Addendum Number: 03

Addendum Issue Date: July 19, 2021

Owner: Crawford Memorial Hospital

Project Name: RHC Addition and Reno

M1.4

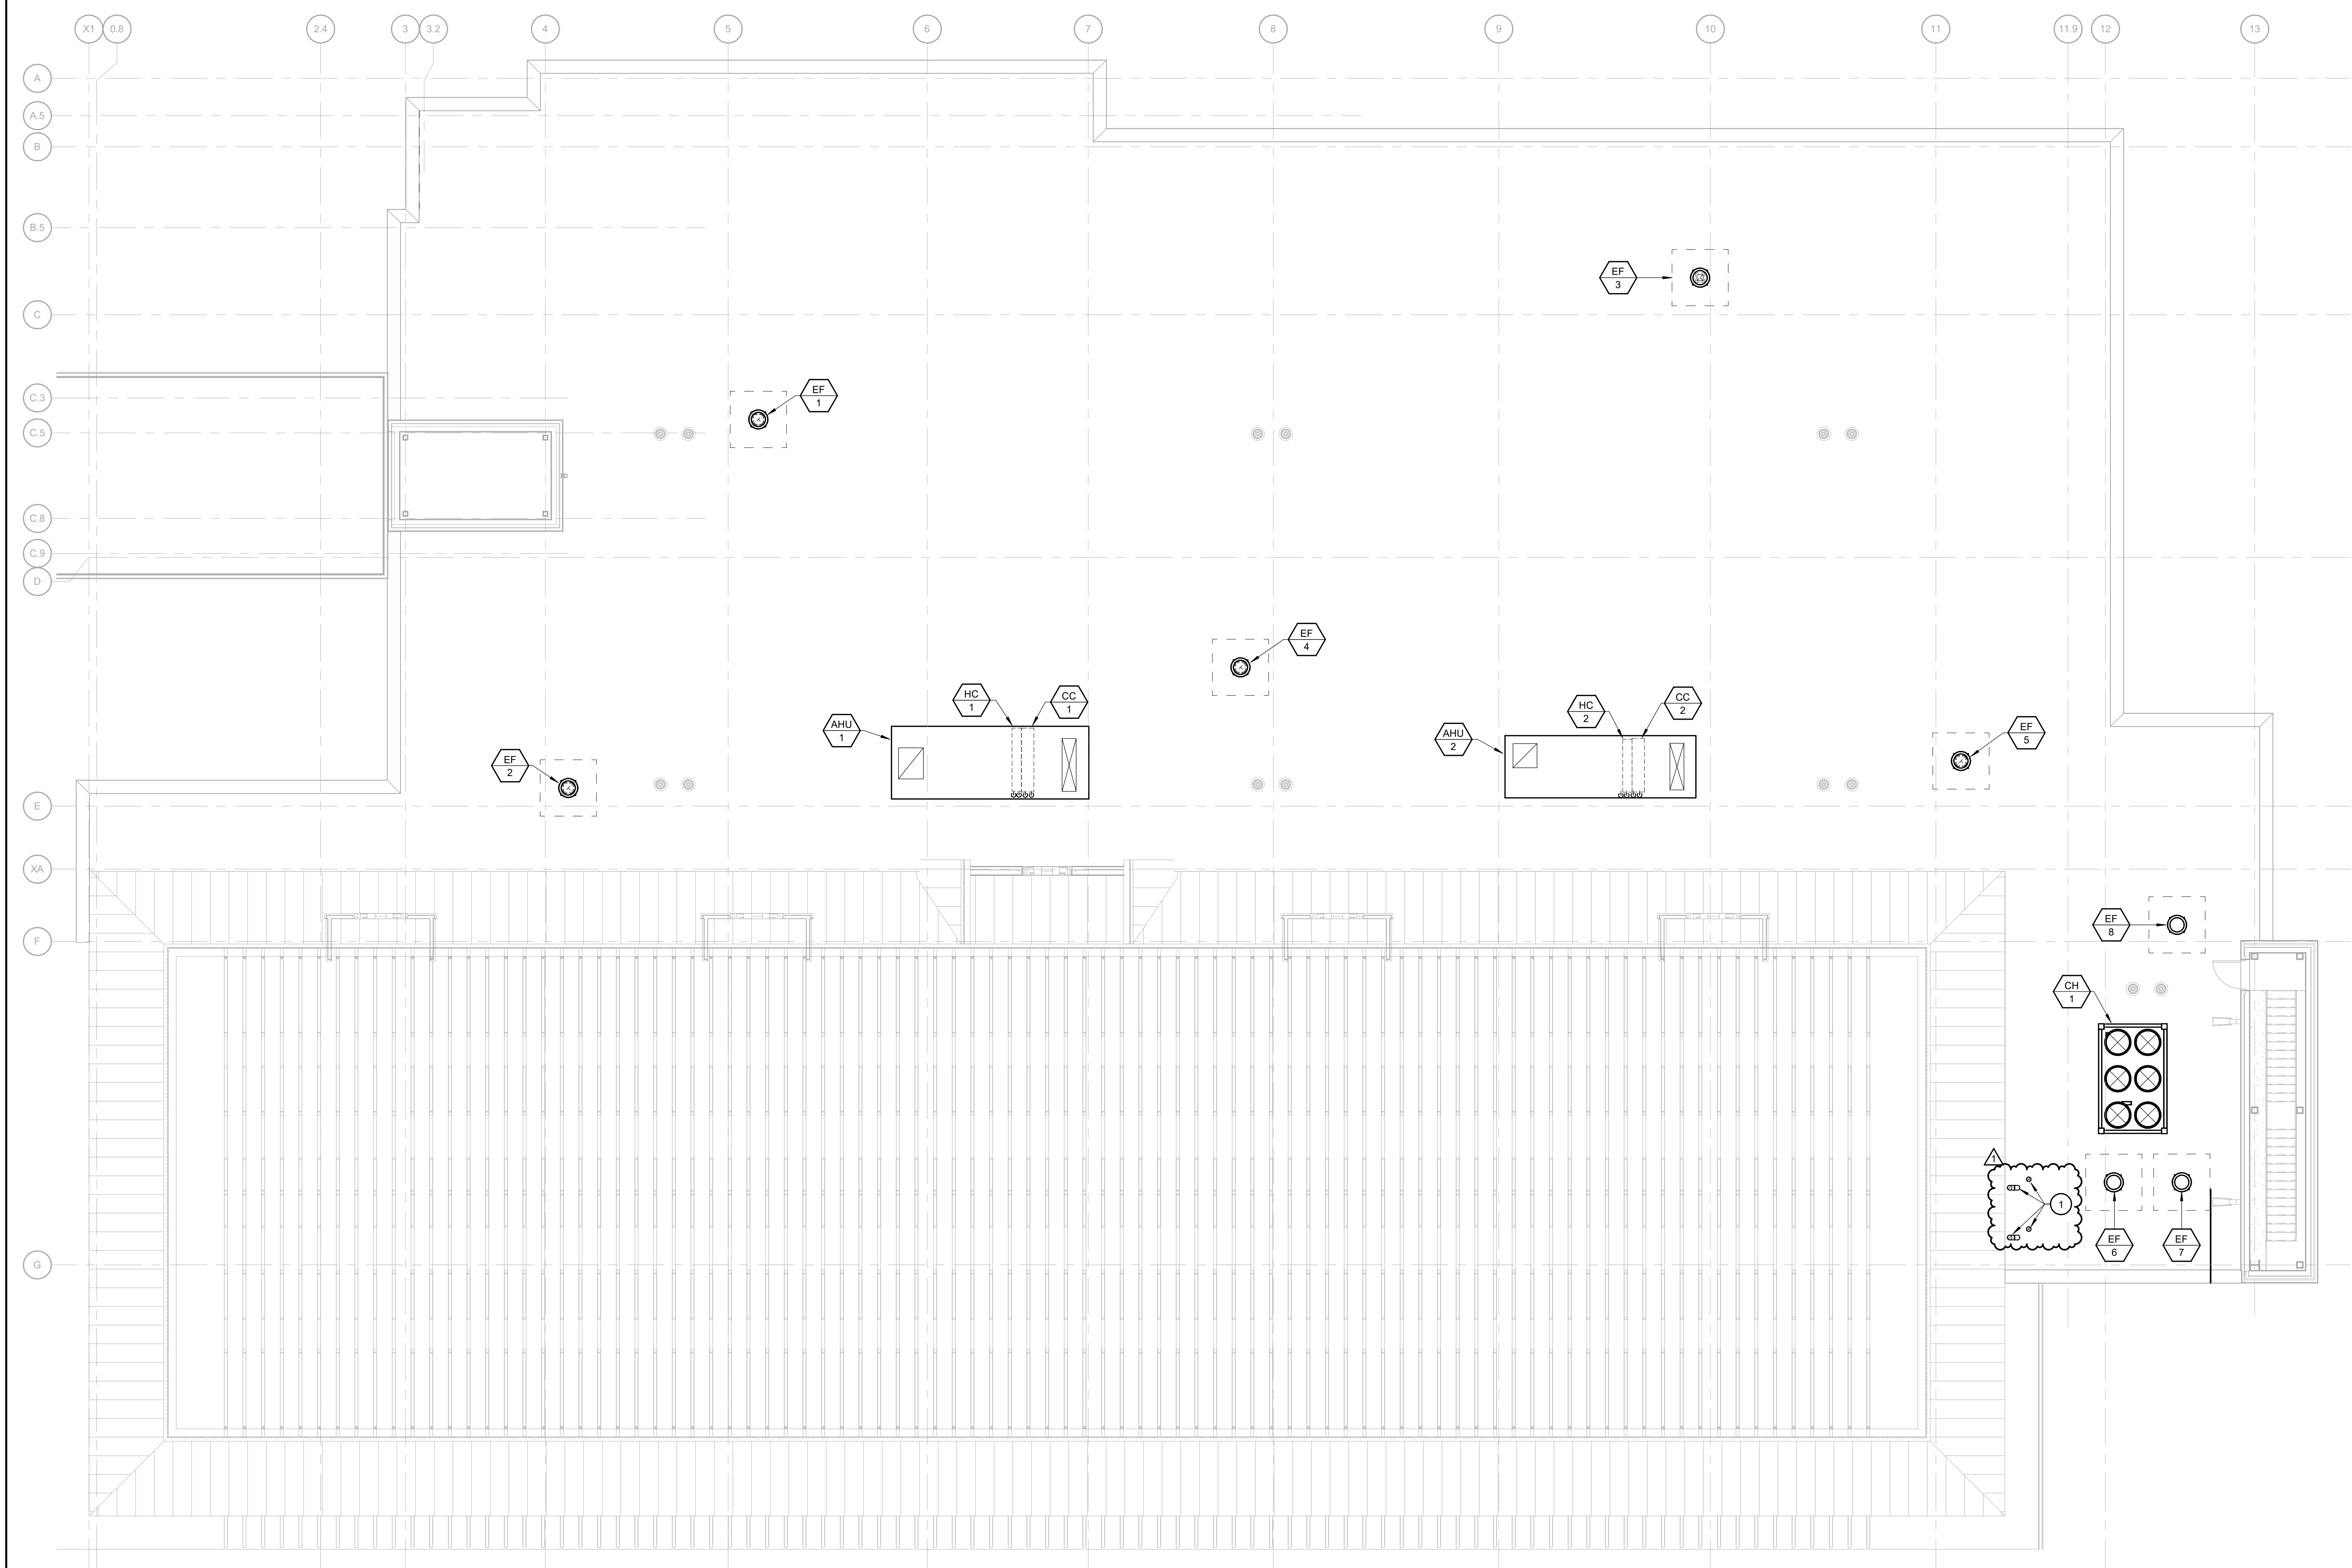
5. M1.4 – MECHANICAL ROOF PLAN

- a. ADD keynote 1.
- b. ADD boiler combustion air intake and exhaust flues as shown.

KEYNOTES
 1 6" COMBUSTION AIR INTAKE AND EXHAUST FLUE TERMINATIONS. INSTALL PER BOILER MANUFACTURER'S WRITTEN INSTRUCTIONS TYP. OF 2.

M3.1

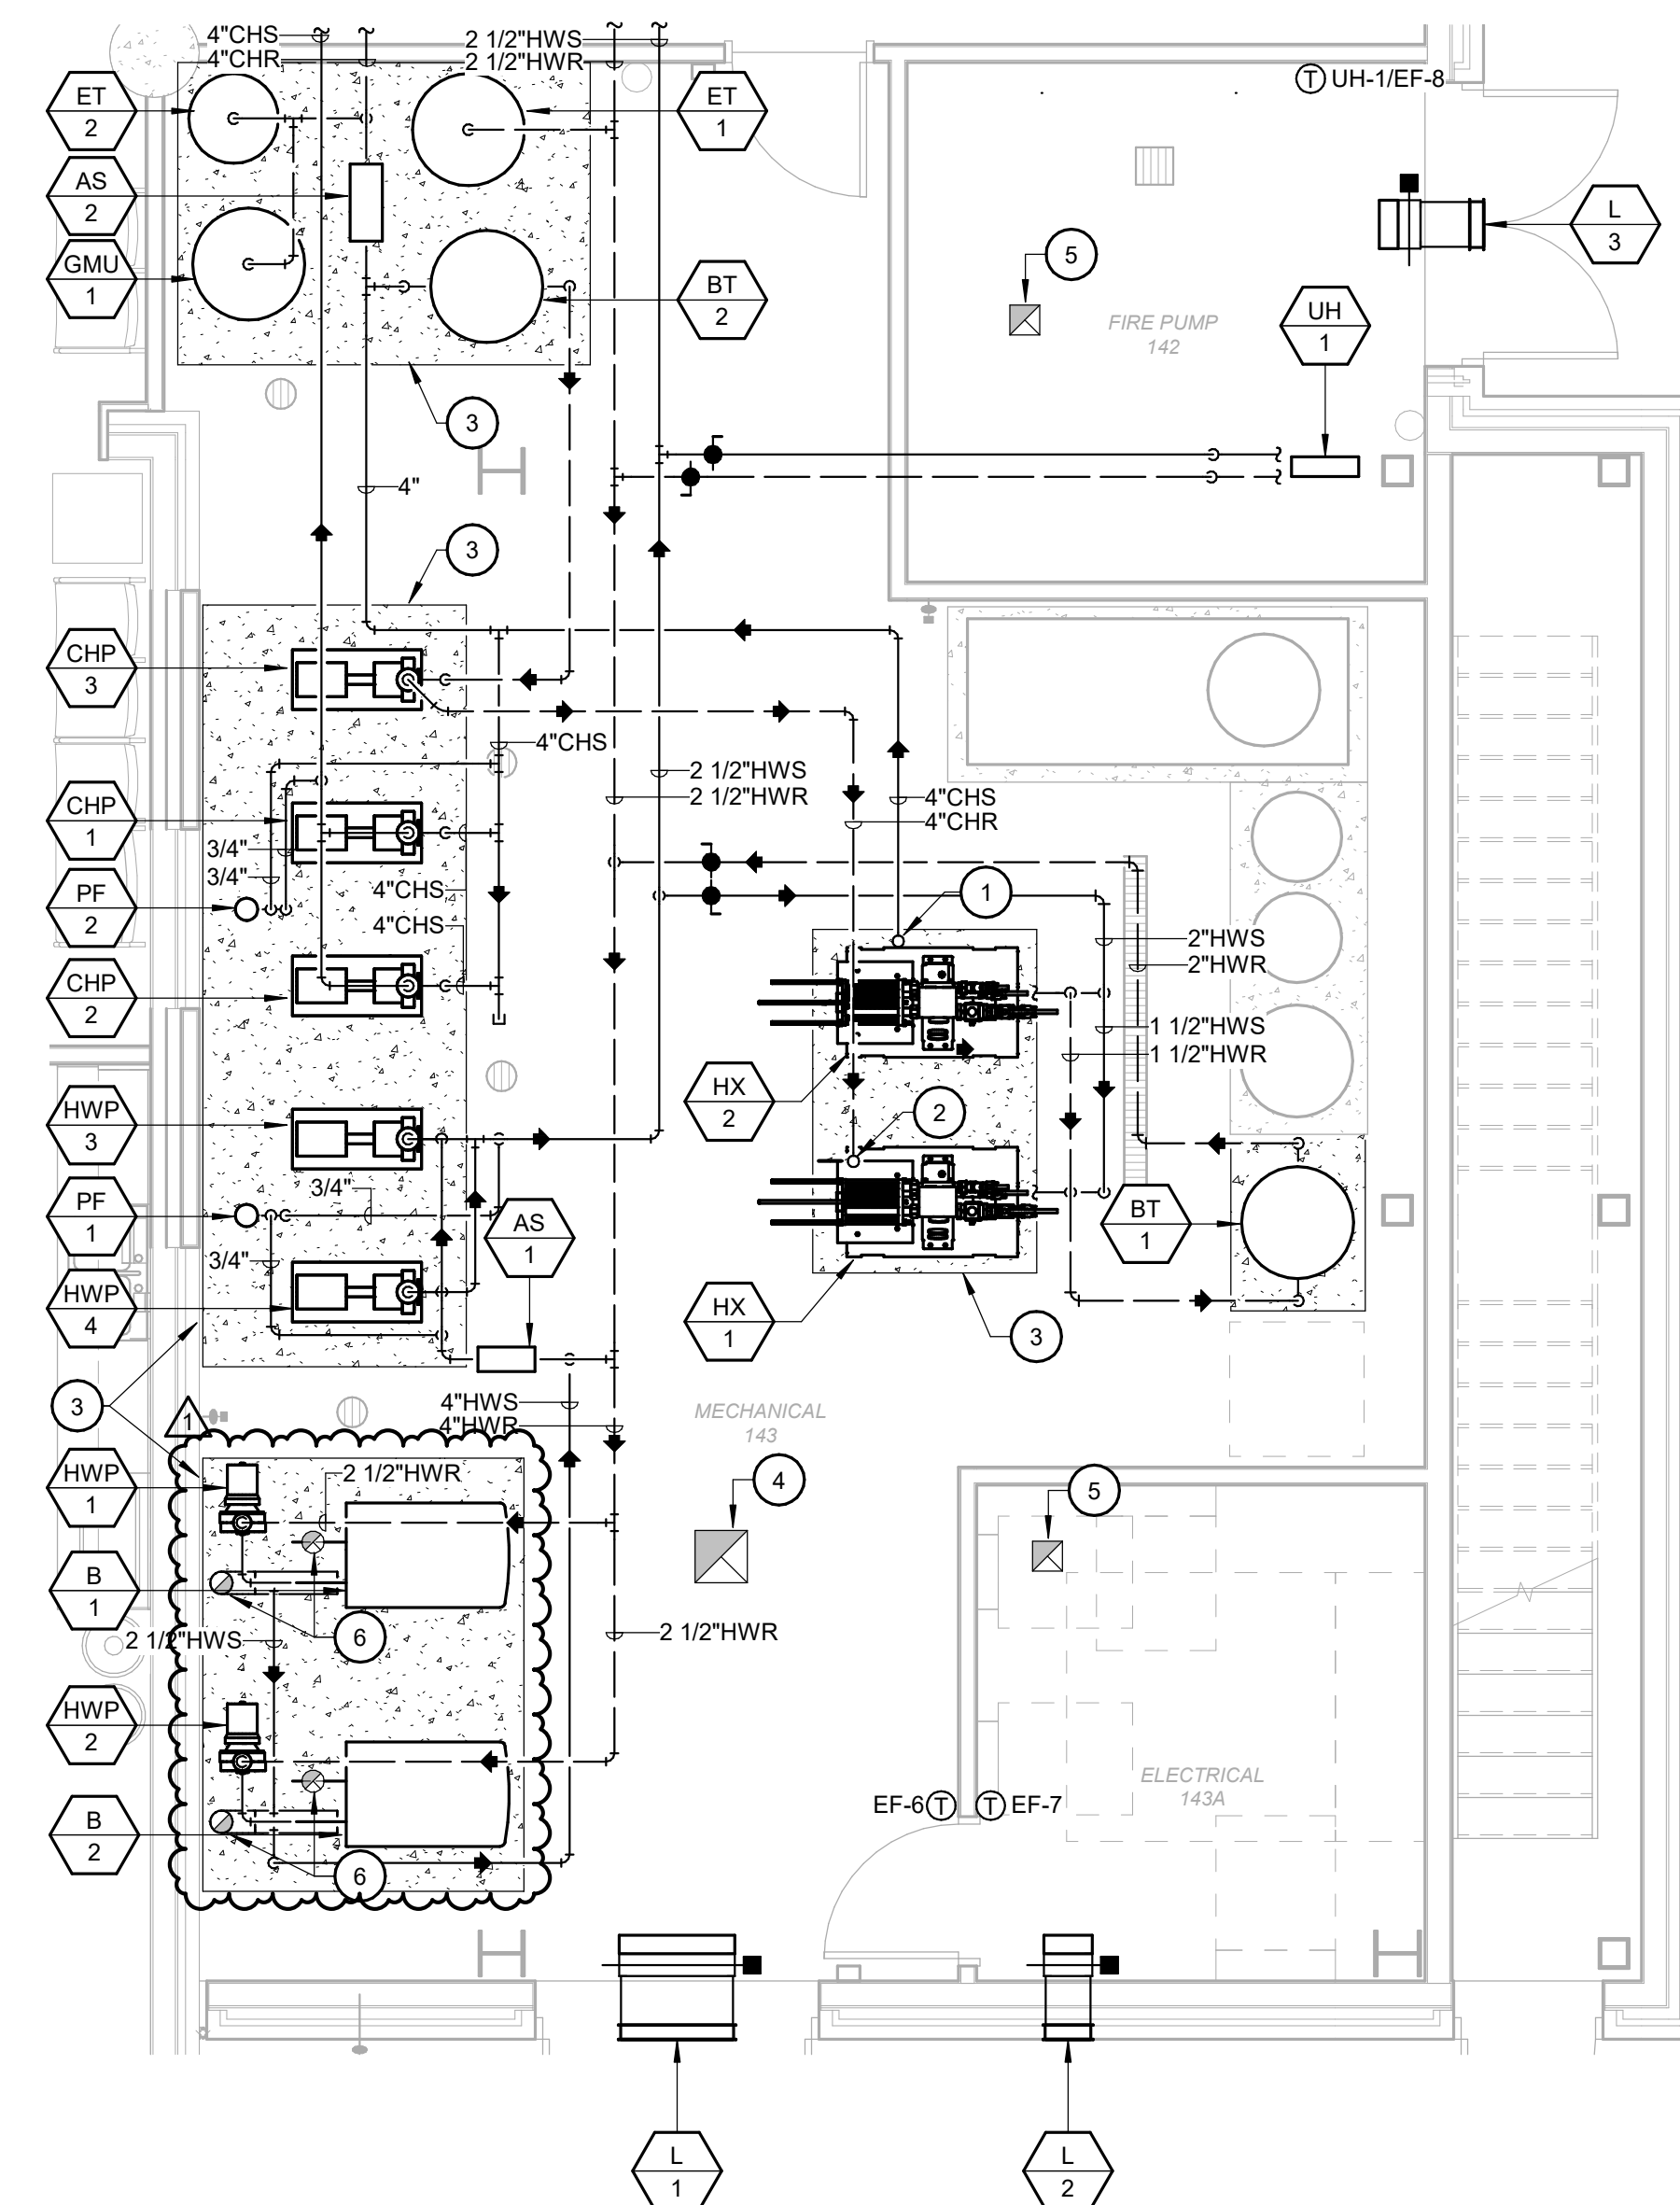
6. M3.1 – ENLARGED PLANS

- a. ADD keynote 6.
- b. ADD boiler combustion air intake and exhaust flues as shown.

- 1 4" CHWS FROM CHILLER ON ROOF ABOVE.
- 2 4" CHWR UP TO CHILLER ON ROOF ABOVE.
- 3 4" THICK CONCRETE HOUSEKEEPING PAD.
- 4 14x14 EA UP TO EXHAUST FAN ON ROOF ABOVE.
- 5 14x14 EA UP TO EXHAUST FAN ON ROOF ABOVE.
- 6 6" COMBUSTION AIR INTAKE FROM ABOVE AND 6" EXHAUST FLUE UP SIZE AND MATERIAL PER BOILER MANUFACTURER'S WRITTEN INSTRUCTIONS.
